NOTICE OF DECISION

CLASS 3 SITE PLAN REVIEW / CLASS 1 ADJUSTMENT CASE NO.: SPR-ADJ24-29

NOTICE OF DECISION DATE: October 22, 2024

REQUEST: A Class 3 Site Plan Review for the development of a new 115 room hotel and associated site improvements including off-street parking and landscaping. The consolidated application includes one Class 1 Adjustment to increase the maximum building height from 45 feet to 50 feet. The subject property is 5.11-acres in size, zoned IP (Industrial Park) and located at 3010 Kettle Court SE (Marion County Assessor's Map and Tax Lot Number 073W25D / 1700).

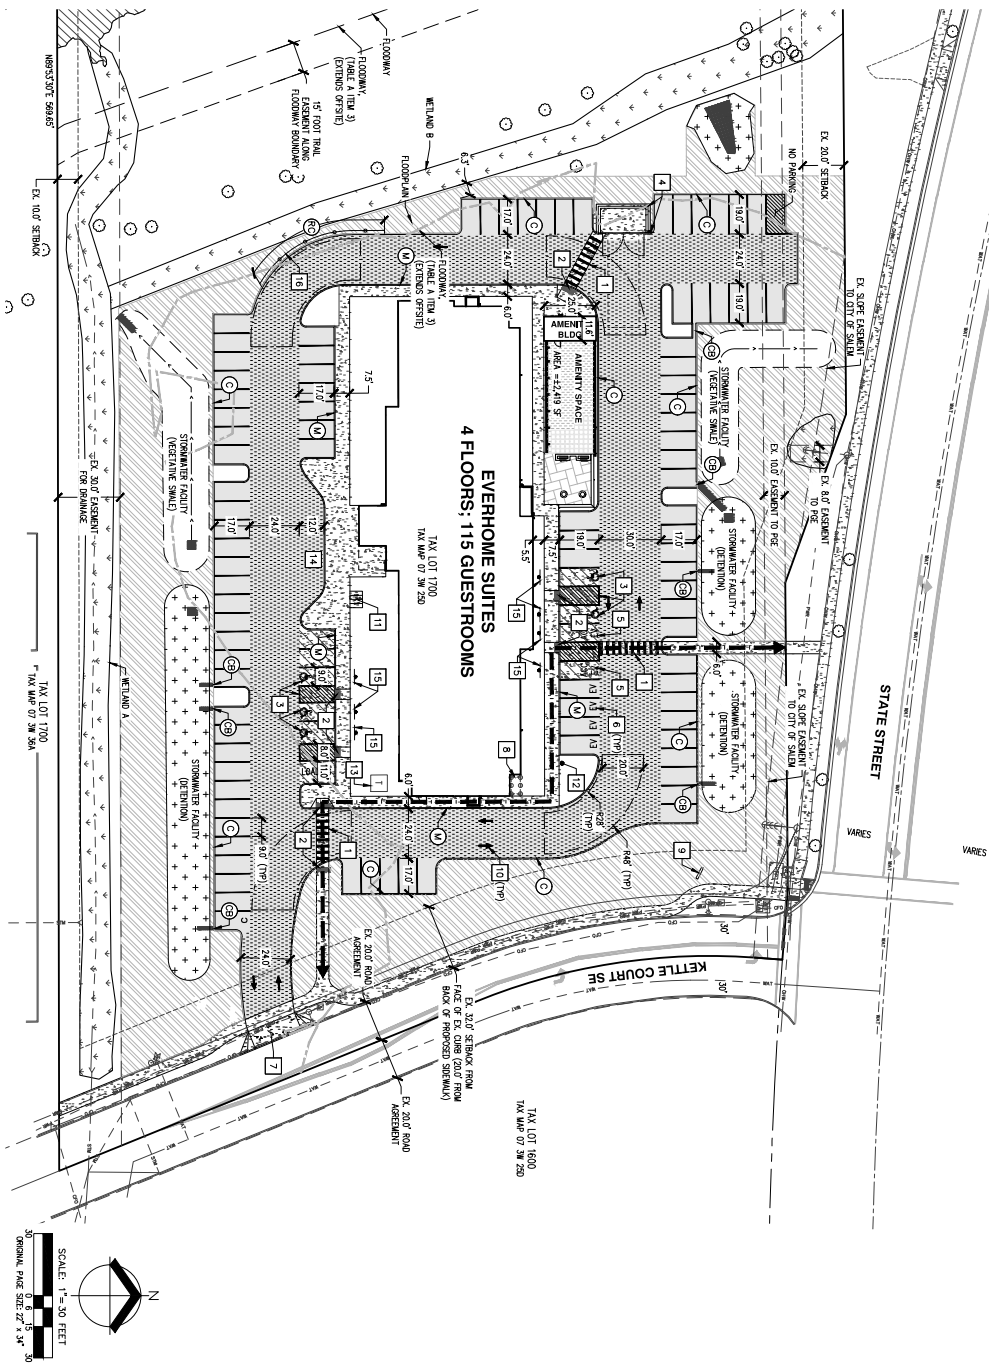
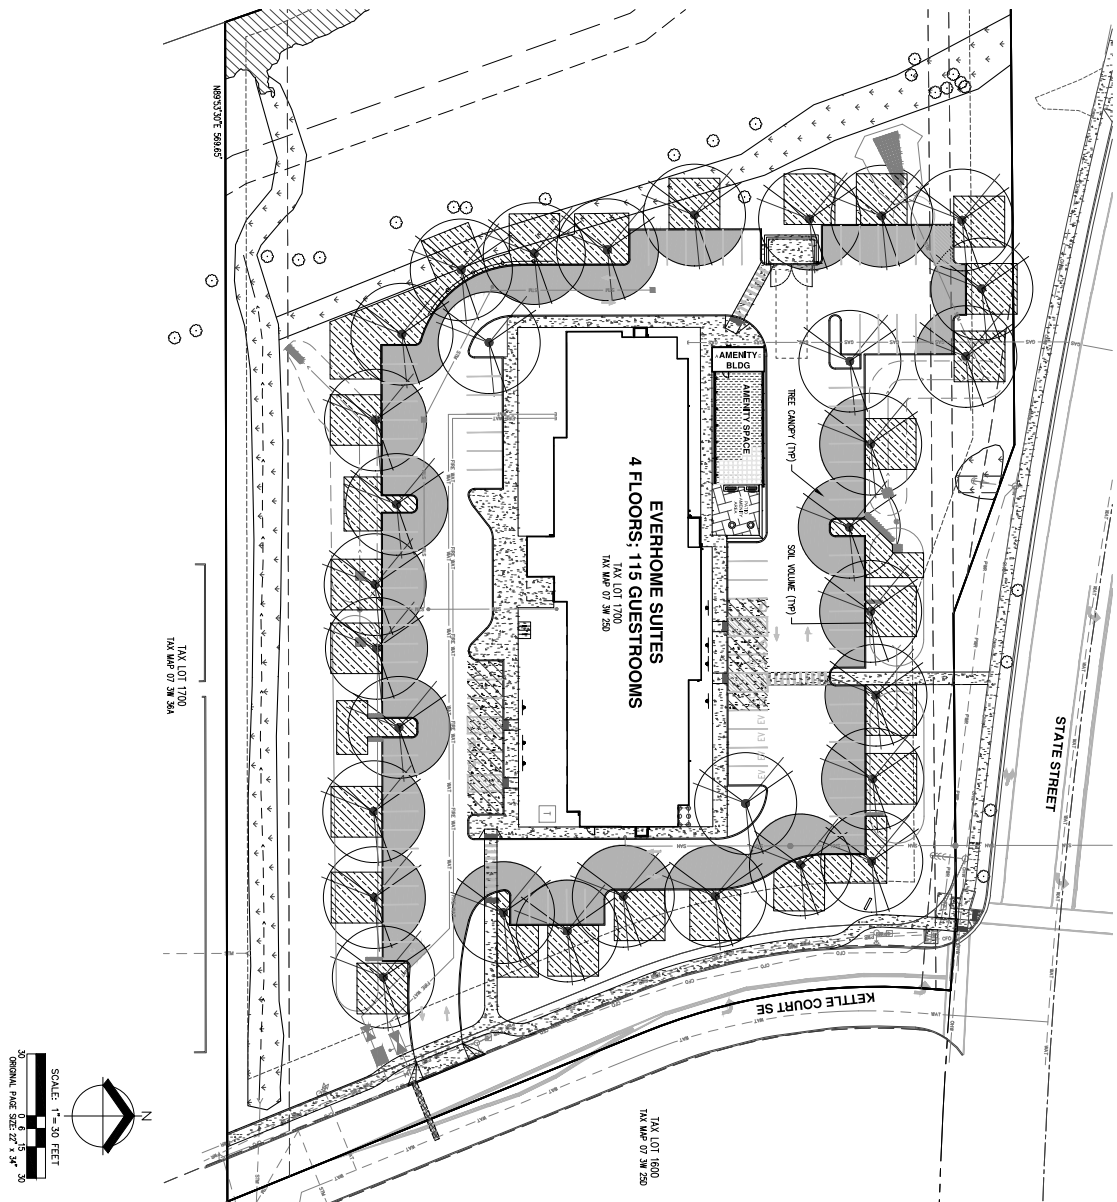
Finding: The development plans include an enclosure with an opening of more than 15 feet, which open a minimum of 90 degrees. Details of restrainers are shown in the closed position but are not shown in the open position. To ensure the enclosure gate will be restrained in both the closed and open positions, the following condition shall apply.

Finding: There are currently no sidewalks located along the Kettle Court SE frontage. The applicant proposes sidewalks along Kettle Court SE that meander between property line, as required by SRC 803.035(l)(2)(A), and curbline. This is due to a conflict with an existing underground power line and limitations from the public utility easement that prohibit planting trees. If the sidewalk is constructed with a landscape strip, as required by the street standards, street trees could not be planted in the landscape strip due to existing franchise utility infrastructure. Therefore, the sidewalk may meander along the curb line as needed to reduce conflicts between the existing underground power line and proposed street trees pursuant to SRC 803.035(l)(2)(B).

Condition 6: Prior to issuance of a certificate of occupancy, construct sidewalks along the Kettle Court SE frontage of the property pursuant to SRC 803.035(l)(2) as specified on the site plan.
